## RE: DP 3639-F, REDEVELOPMENT OF BIG MOOSE SKI RESORT

Big Lake Development LLC would like to provide the following update in response to the ongoing MDIFW review of the project. Based upon a previously submitted response by Big Lake Development LLC, MDIFW posed additional questions relative to the planned work and the methodology associated with the wildlife studies. Since their response was received, we have finalized these additional studies that provide more definitive information and will hopefully answer any remaining concerns.

Designed By FAB/JAO	Drawn By FAB/JAO
Date 03/04/2022	Scale AS SHOWN
<b>BIG LAKE DEVELOPMENT, LLC</b> <b>BIG MOOSE RESORT</b> SKI RESORT RD. Project Location BIG MOOSE TOWNSHIP, MAINE Drawing Description <b>SITE PLAN - CHAIRLIFT</b>	
Approved	Checked

Sheet No.  
**WE-2**

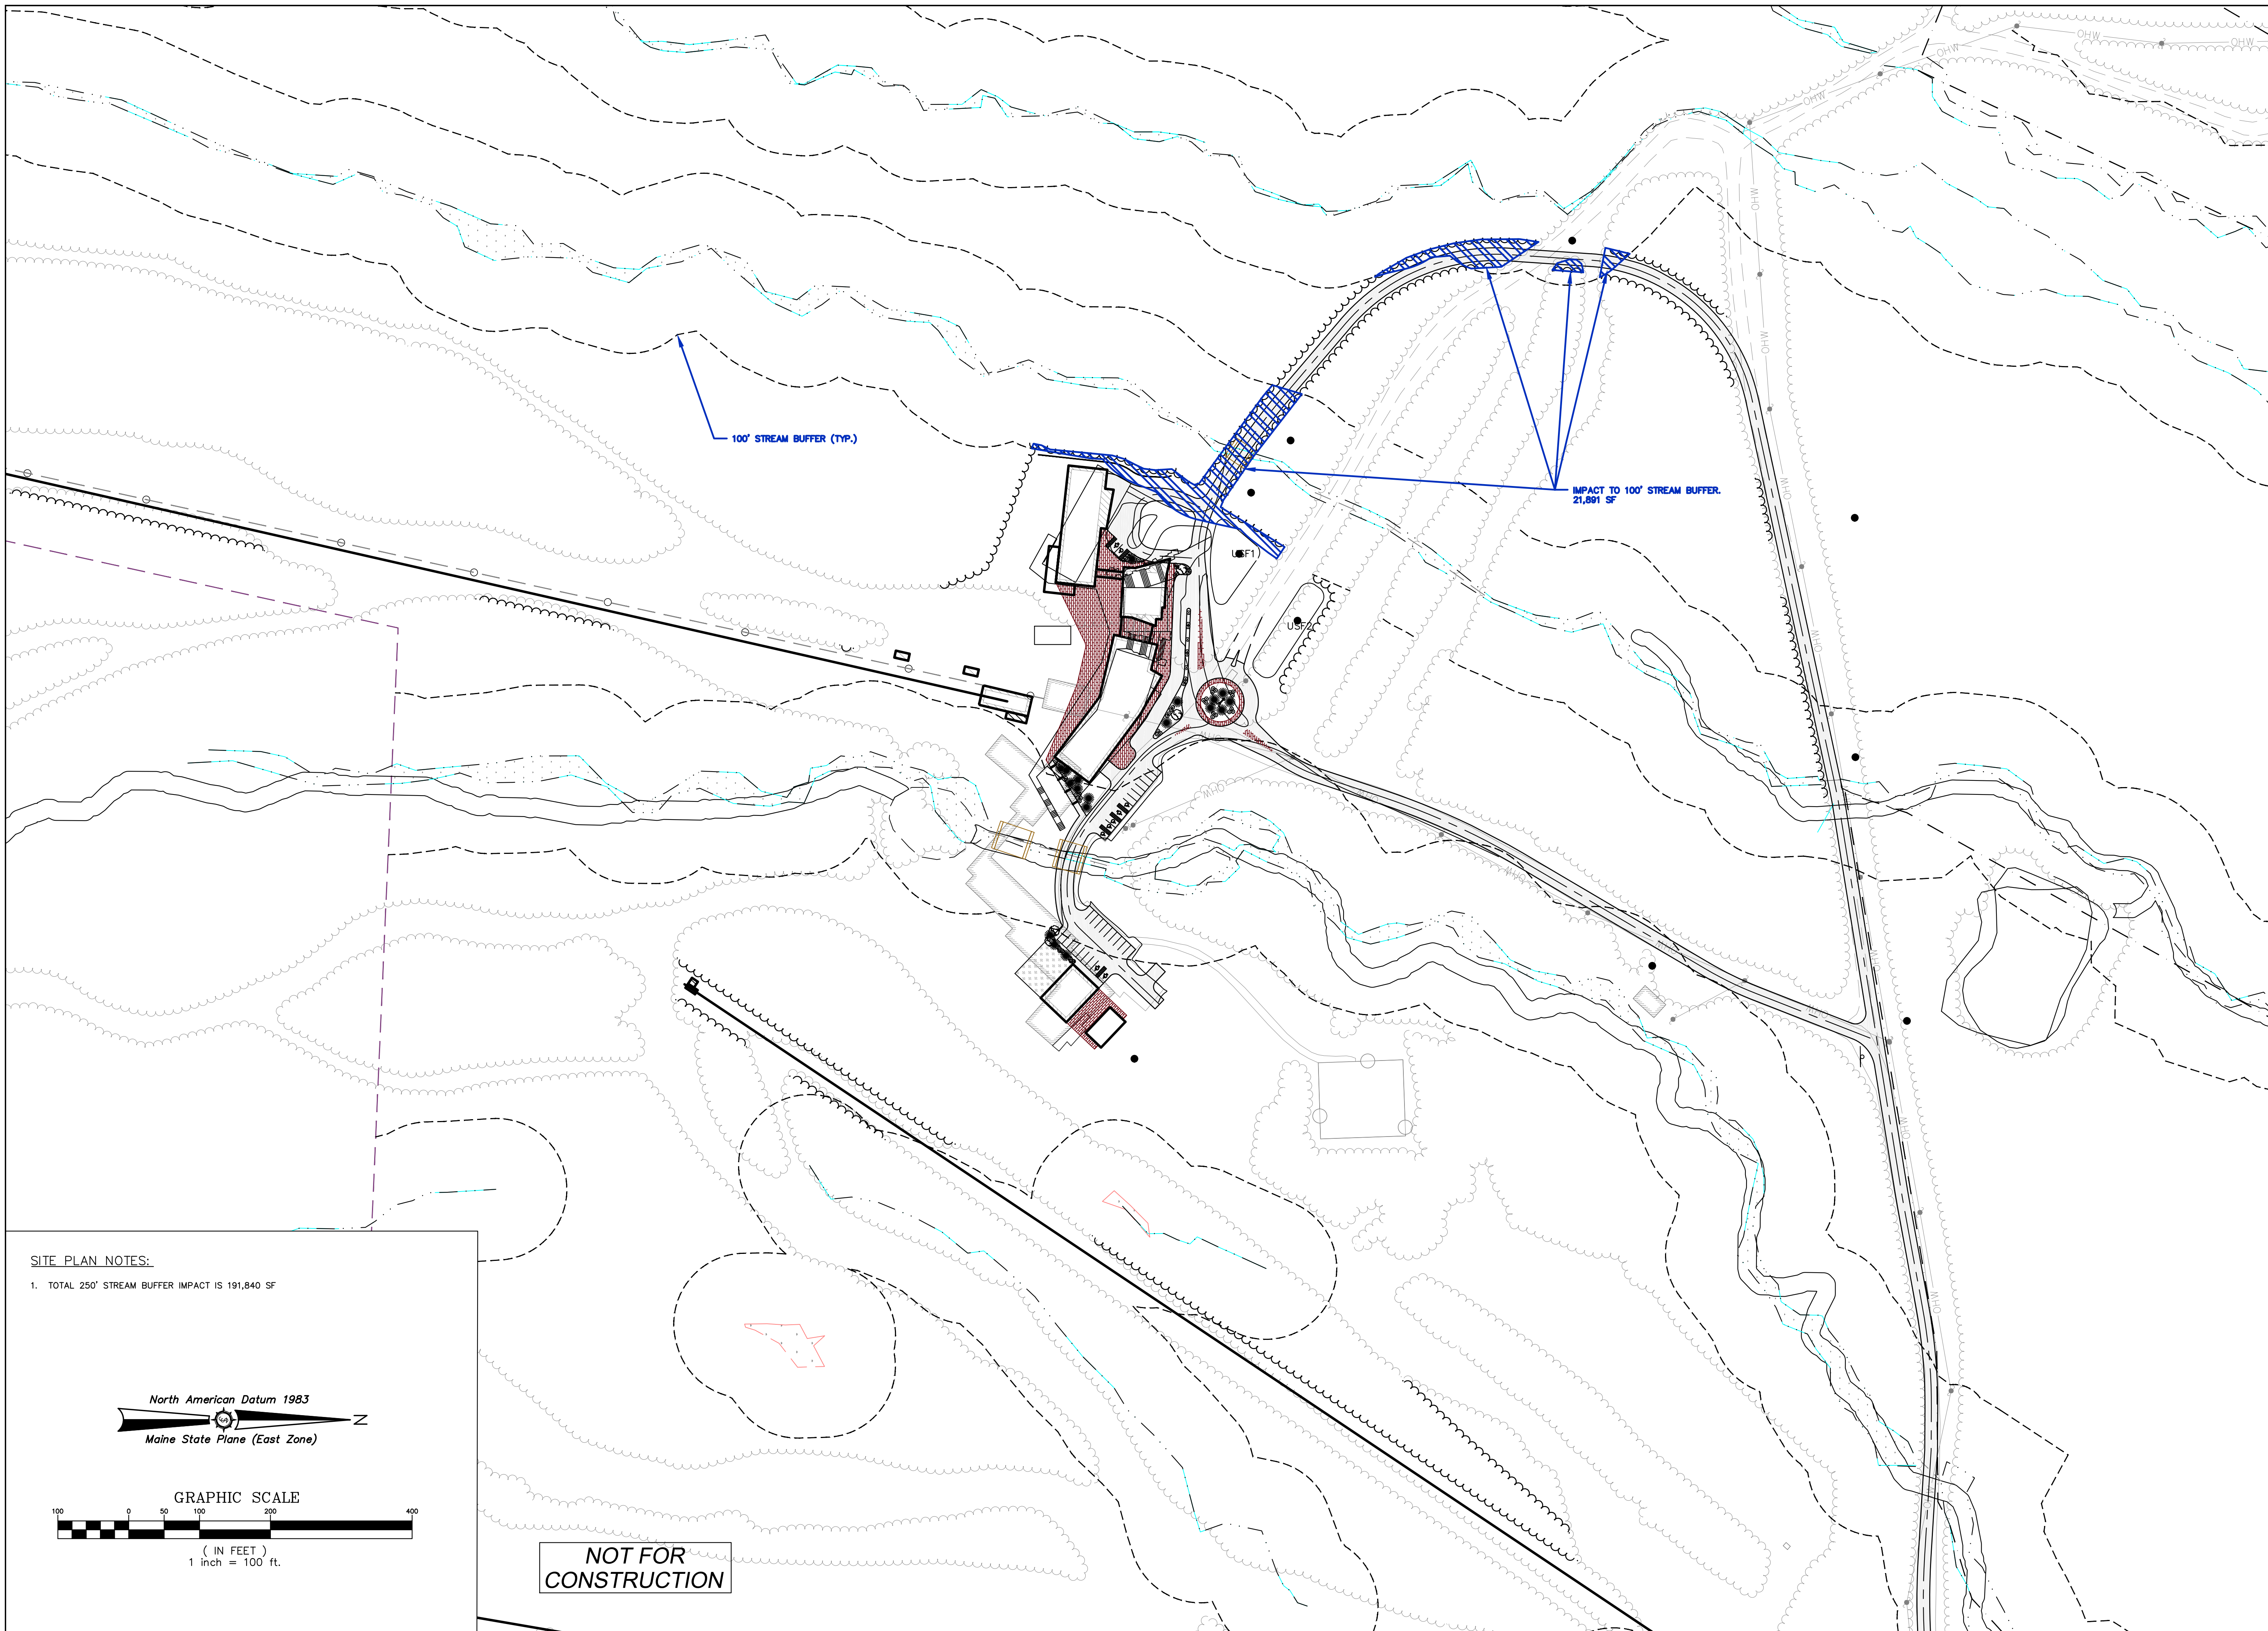
**Bicknell's Thrush:** Attached is a plan that provides more detail on the land proposed to be set aside for Bicknell's Thrush habitat. Within the potential habitat range, it has been proposed that an area slightly greater than ½ acre will require some disturbance to accommodate the upper terminal of the zipline. We have conservatively estimated this area as the installed cable will actually run above the canopy in this area. The upper terminal construction requires the installation of a substantial concrete foundation that will support the cable. Details of this proposed construction are included in the original LUPC permit application. The total area that will be set aside as protected habitat exceeds 127 acres, creating a ratio of approximately 223: 1, well in excess of the suggested 4:1 ratio. Additionally, the proposed habitat preservation area borders an additional 97+ acres that is part of the SD Warren parcel that is owned by the State of Maine and managed by the Maine Bureau of Parks and Lands. The relationship of this contiguously protected habitat relative to the proposed disturbed area is shown on the attached plan.
